DN-59

# TECHNICAL BULLETIN

**SUBJECT:** INSTALLATION OF CABIN HEAT DUCT (FIBERGLASS) ASSEMBLIES,  
PN 369D22009-101 AND PN 369D22009-103

**MODELS AFFECTED:** 500D Model 369D Helicopter Serial No. 0003D through 0660D  
equipped with PN 369H90020-517 Heating System

Figure 1. Installation of Fiberglass Cabin Heat Ducts, PN 369D22009-101 and -103 (Sheet 1 of 2)

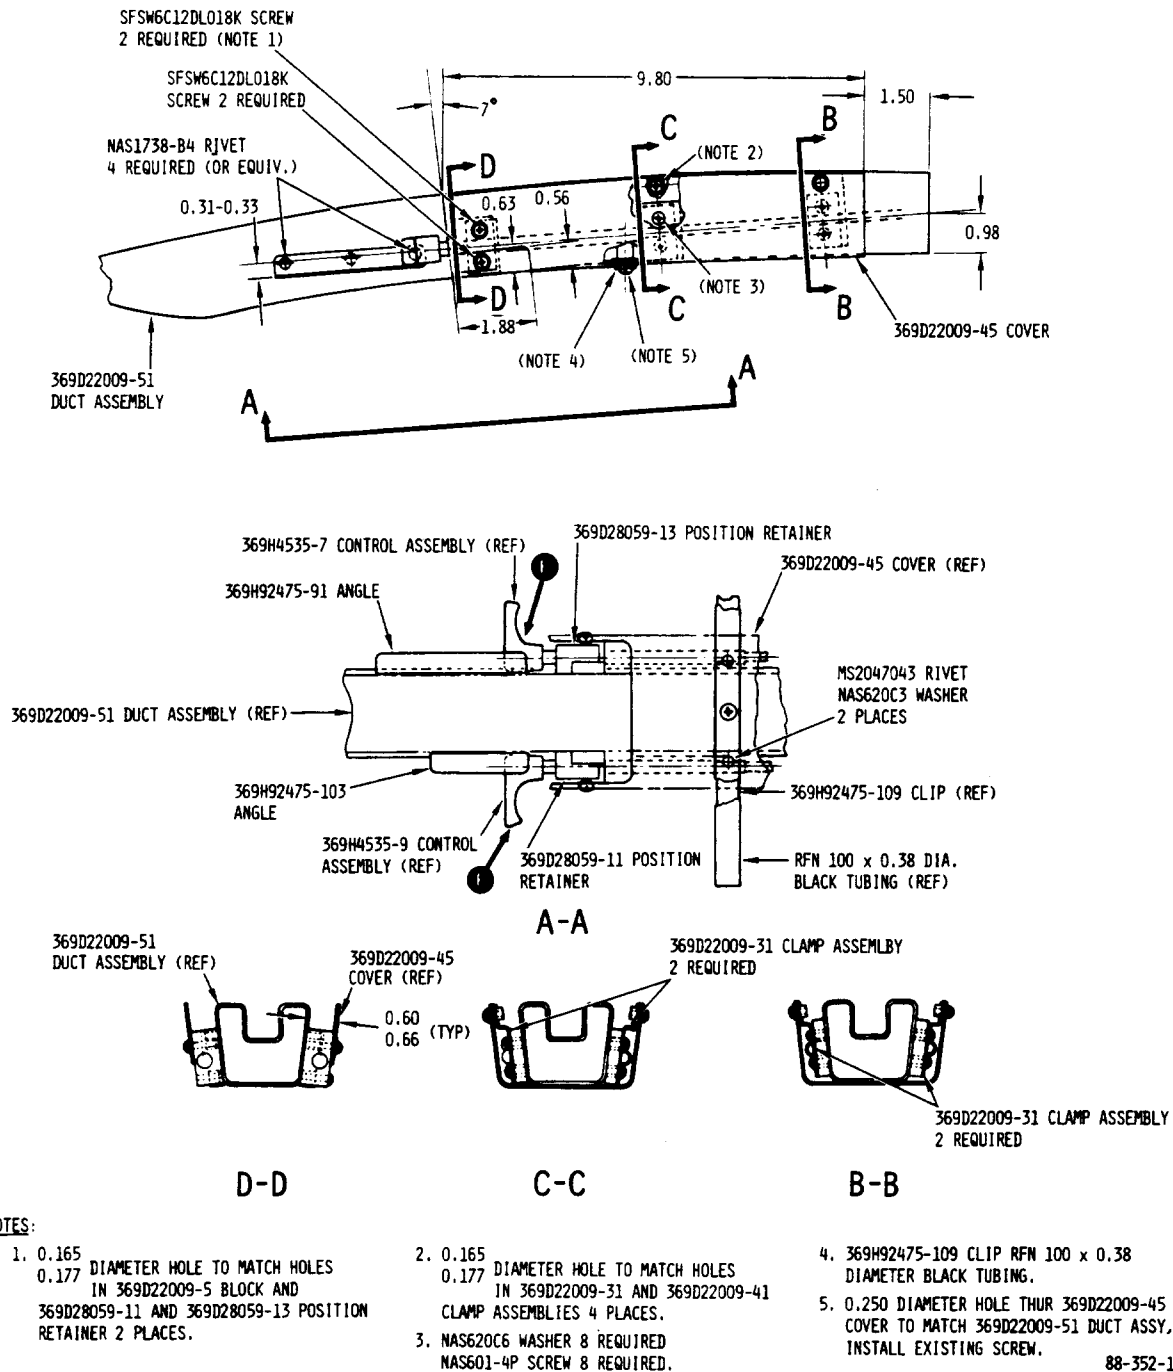
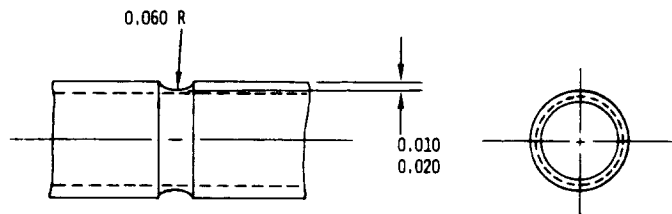
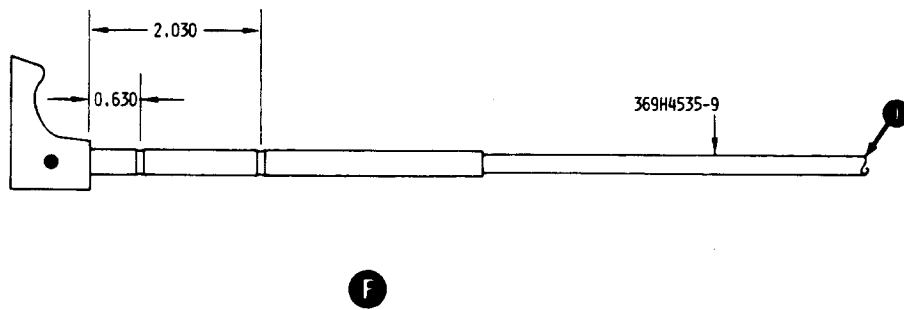
**PREFACE:** The information given in this Service Information Notice lists instructions  
for replacement of the existing Lexan-type cabin heat duct, PN  
369H92475-83 or -107, with a new fiberglass-type cabin heat duct, PN  
379D22009-101. The fiberglass duct configuration is designed to provide  
greater resistance against heat, deformation and wear.

\*369H4535-3 and 369H4535-5 control assemblies used with 369H92475-83 cabin heat duct assembly may be reworked to 369H4535-7 and -9 configurations required for use with new 369D22009-101 heating duct assembly. See Figure 1 for rework dimensions.

- a. Remove outer box from PN 369H92475-83 or -107 cabin heat duct and canopy frame. (Refer to referenced CSP-013. )
- b. Remove hardware securing heating and anti-ice control cable assemblies to heat duct; remove heat duct assembly. Remove existing PN 369H92475-31 or -101 cabin heat (lower) duct assembly. (See Figure 1. )

1. If PN 369H92475-83 heat duct was installed, rework existing PN 369H4535-3 and -5 control cable assemblies to new 369H4535-7 and -9 configurations per step c below.
  2. If PN 369H92475-107 heat duct was installed, rework of existing 369H4535-7 and -9 control cable assemblies is not required.
- c. Using file or equivalent, rework control handle shafts to provide detents, per dimensions shown in Figure 1.
  - d. Install new PN 369D22009-103 and 369D22009-101 fiberglass heat duct assemblies.

Figure 1. Installation of Fiberglass Cabin Heat Ducts, PN 369D22009-101 and -103 (Sheet 2 of 2)

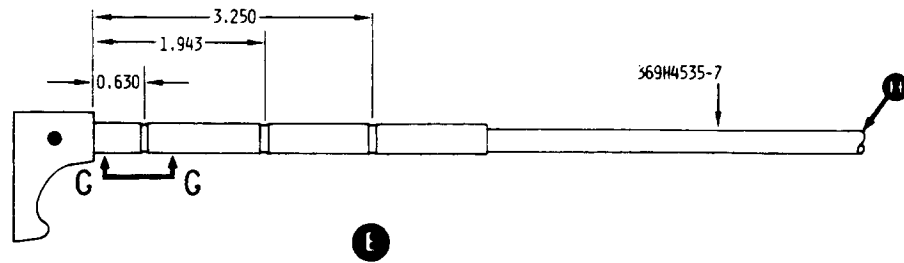
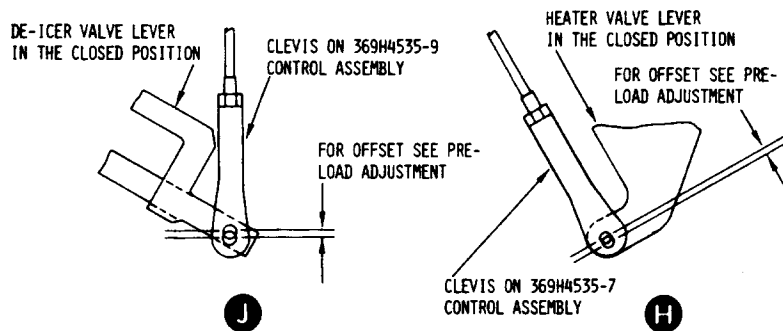
- h. Adjust preload of new PN 369H4535-7 and -9 control assemblies as follows: (See Figure 1.)
  - 1. Remove clevis from lever of applicable valve and loosen jam nut above clevis.
  - 2. With handle of 369H4535-7 or -9 control assembly in CLOSED position, adjust control cable clevis to initially align holes in clevis and valve lever.
  - 3. After initial adjustment has been made, turn clevis 1 to 2 turns, in extension, to achieve offset as shown.
  - 4. Tighten jam nut and install clevis pin.
- i. Perform operational check of heating system, per referenced CSP-013. Reinstall aft bulkhead access cover and interior trim.
- j. Perform operational check of anti-icing system, per Section 11 of Basic HMI-Volume I. Close plenum chamber access door.
- k. Install new PN 369D22009-45 cover with hardware as shown.

WITH THE HANDLE OF THE 369H4535-7 OR -9 CONTROL ASSEMBLY IN THE CLOSED POSITION DETENT, ADJUST THE CONTROL CABLE CLEVIS TO INITIALLY ALIGN HOLES IN THE CONTROL CABLE CLEVIS AND THE VALVE LEVER OF APPLICABLE VALVE. AFTER INITIAL ADJUSTMENT HAS BEEN MADE, TURN CLEVIS 1/2 FULL TURNS, IN EXTENSION, TO ACHIEVE OFFSET AS SHOWN. TIGHTEN JAM NUT AND INSTALL MS20392-2C11 CLEVIS PIN.
